**TOWN OF ADDISON  
BUILDING REPORT**

**Facility Information:** **Facility Name:** Finance Building  
**Facility Contact:** Lisa Pyles **Contact Phone:** 972-450-2878

**Accessology Inspector Information:**  
**Inspector:** Karen Jackson **Date:** April 21, 2017  
**Email:** Kjackson@accessology.com

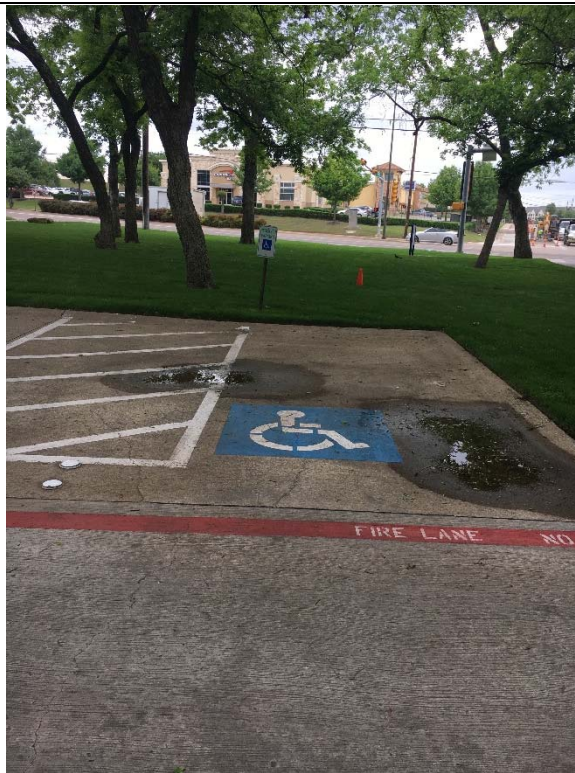
**Violation 1** - The access aisle has slopes ranging from 2.4% to 4.4%.

**Violation 2** - There is evidence of ponding in the accessible parking space.

**Violation 3** - The accessible signage is mounted too low.

**Violation 4** - There is no elevator serving this building, therefore there is no access to the 2nd floor.

**Violation 5** - The building entrance has a 7.9% sloped area at the building entrance.

**Violation 6** - The threshold at the entrance door is greater than 1/2".

**Possible Solutions:** Repave access aisle to achieve slopes in all directions no greater than 1:48. Cost for corrections is included under Violation #2.

**Possible Solutions:** Repave area to achieve a smooth surface.

**Possible Solutions:** Raise signage.

**Possible Solutions:** Install a compliant elevator unless all programs can be moved to more accessible location.

**Possible Solutions:** Modify building entrance to be served by a level maneuvering clearance.

Modify threshold to achieve a change in level no greater than 1/2".

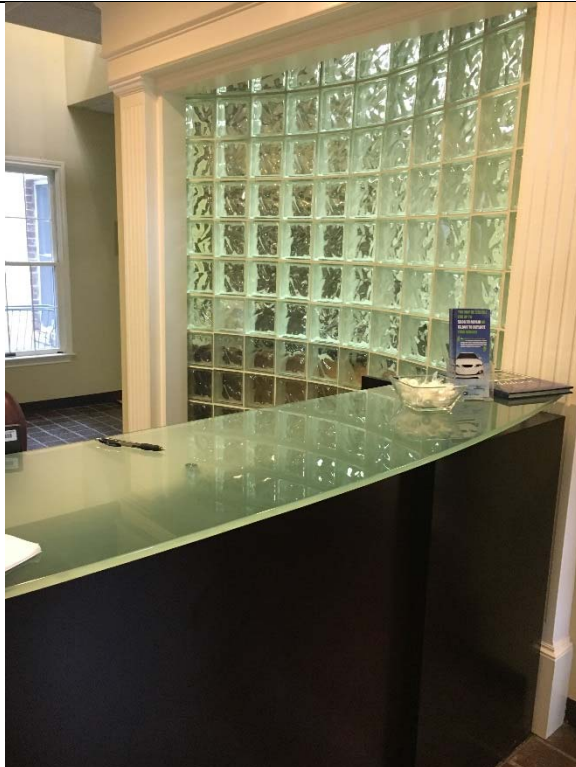
**Violation 7** - The entrance door has a door stop at the bottom, therefore, the bottom 10" of the door does not have a smooth surface.

**Violation 8** - The reception desk is 44" above finished floor to the top of the counter.

**Violation 9** - There are approximately 12 door knobs provided throughout the facility.

Remove door stop. This is a TDLR requirement not a Federal standard.

Replace desk or provide a portion of the desk that is no higher than 36" above finished floor.

Replace with lever type handles.

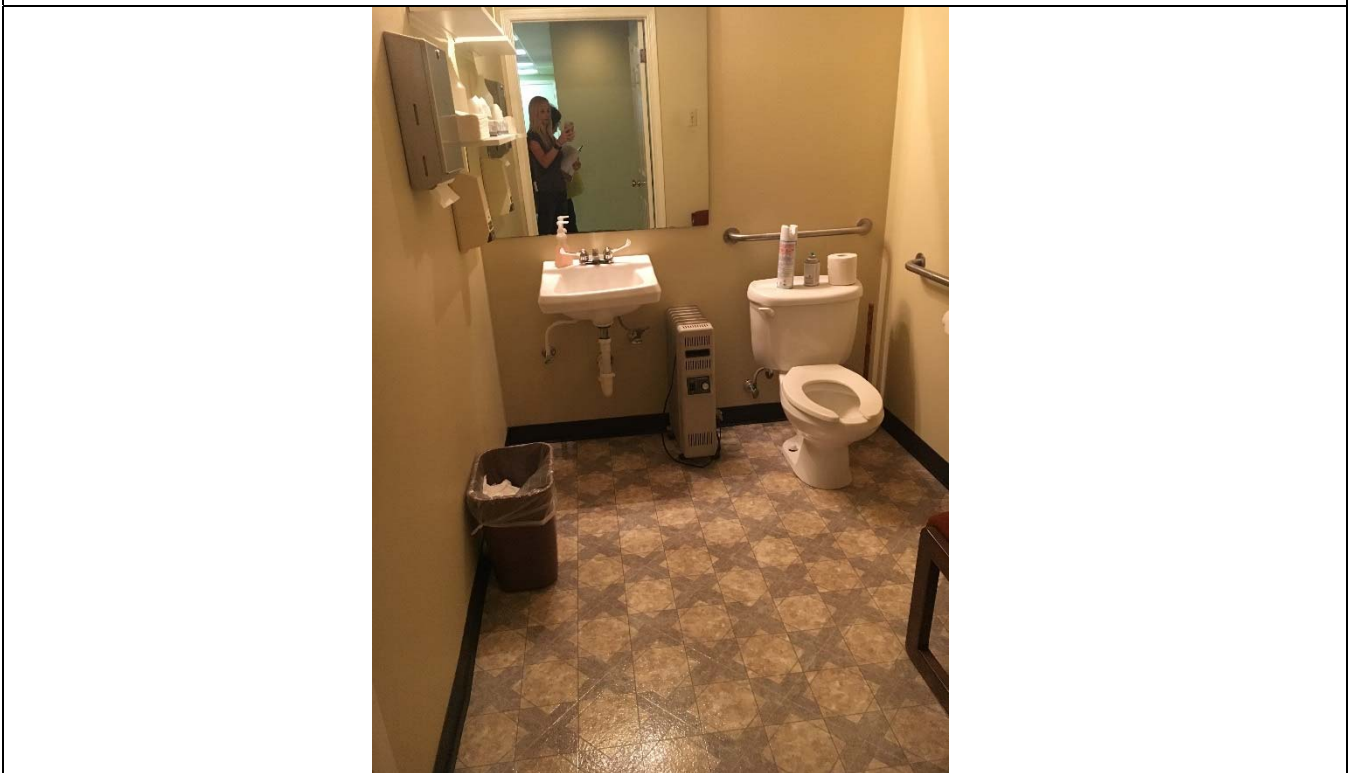
**Violation 10** - Women's Restroom: Signage is mounted on the wall next to the hinge side of the door.

**Violation 11** - Women's Restroom: The required clear floor space around the water closet is not provided.

**Violation 12** - Women's & Men's Restrooms: Water closet seats are 15.5" above finished floor.

**Violation 13** - Women's & Men's Restrooms: The space between the grab bar and the wall is 2".

**Violation 14 - Women's Restroom:** The rear grab bar is only 24" long.

**Violation 15 - Women's Restroom:** The rear grab bar is mounted too high at 37" above finished floor.

**Violation 16 - Women's Restroom:** Lavatory pipes and valves are not wrapped to protect against contact.

Relocate signage to the latch side of the door.

Remove and relocated lavatory to achieve required clear floor space.

Install a complaint water closet in each restroom.

Remove and remount grab bars so that 1-1/2" clearance is achieved.

Install a compliant grab bar. The cost for compliance is included in Violation #13.

Remount grab bar to compliant height. The cost for compliance is included in Violation #13.

Provide protection at the exposed drains and water lines under the lavatories.

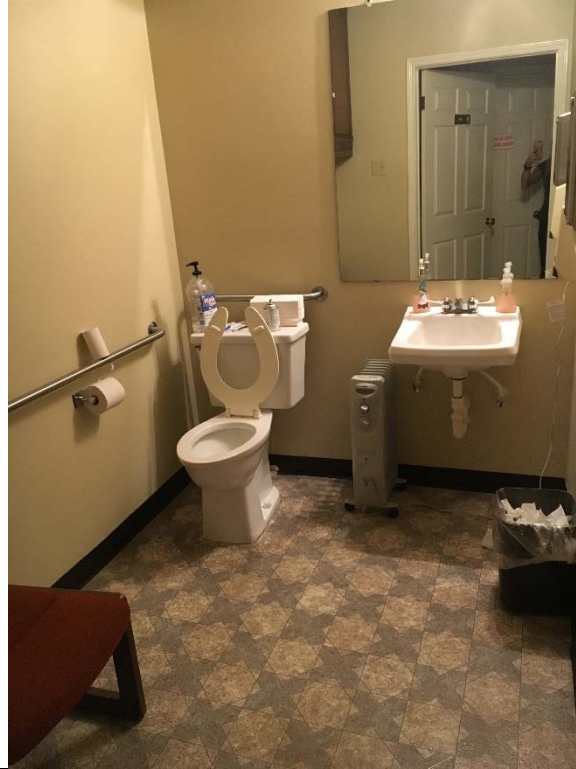
**Violation 17 - Men's Restroom:** Signage is mounted on the wall next to the hinge side of the door.

**Violation 18 - Men's Restroom:** The required clear floor space around the water closet is not provided.

**Violation 19 - Men's Restroom:** The rear grab bar is only 24" long.

**Violation 20 - Men's Restroom:** The rear grab bar is mounted too high at 37" above finished floor.

Relocate signage to the latch side of the door.

Remove and relocate lavatory to achieve required clear floor space.

Install a compliant grab bar. The cost for compliance is included in Violation #18.

Remount grab bar to compliant height. The cost for compliance is included in Violation #18.

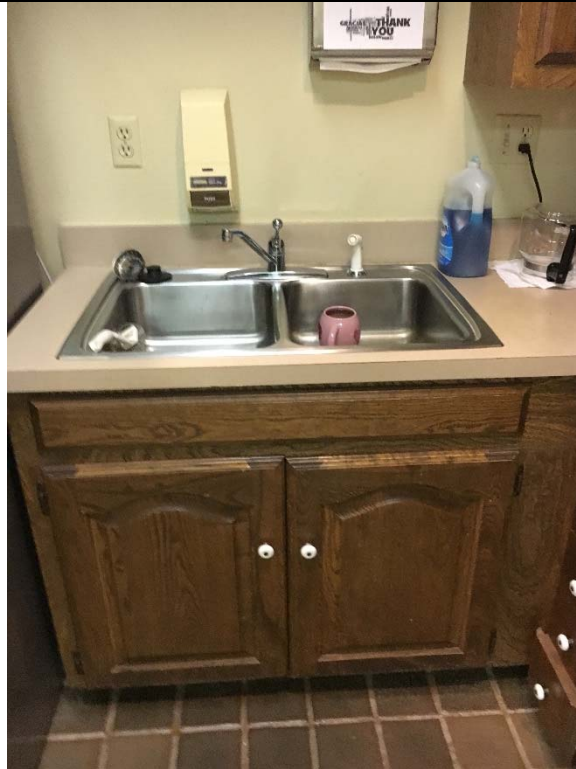
**Violation 21 -** The sink is mounted higher than 34" above finished floor.

**Violation 22** - The sink does not have the required knee clearance provided.

**Violation 23** - The microwave is mounted above 48" to the highest operable part.

**Possible Solutions:** Lower sink ensure front of the rim or counter surface is 34 inches maximum above the finish floor or ground.

Modify cabinets to provide the required toe and knee clearance. The cost for compliance is included in Violation #21.

Relocate microwave so that it is located within the required reach range.
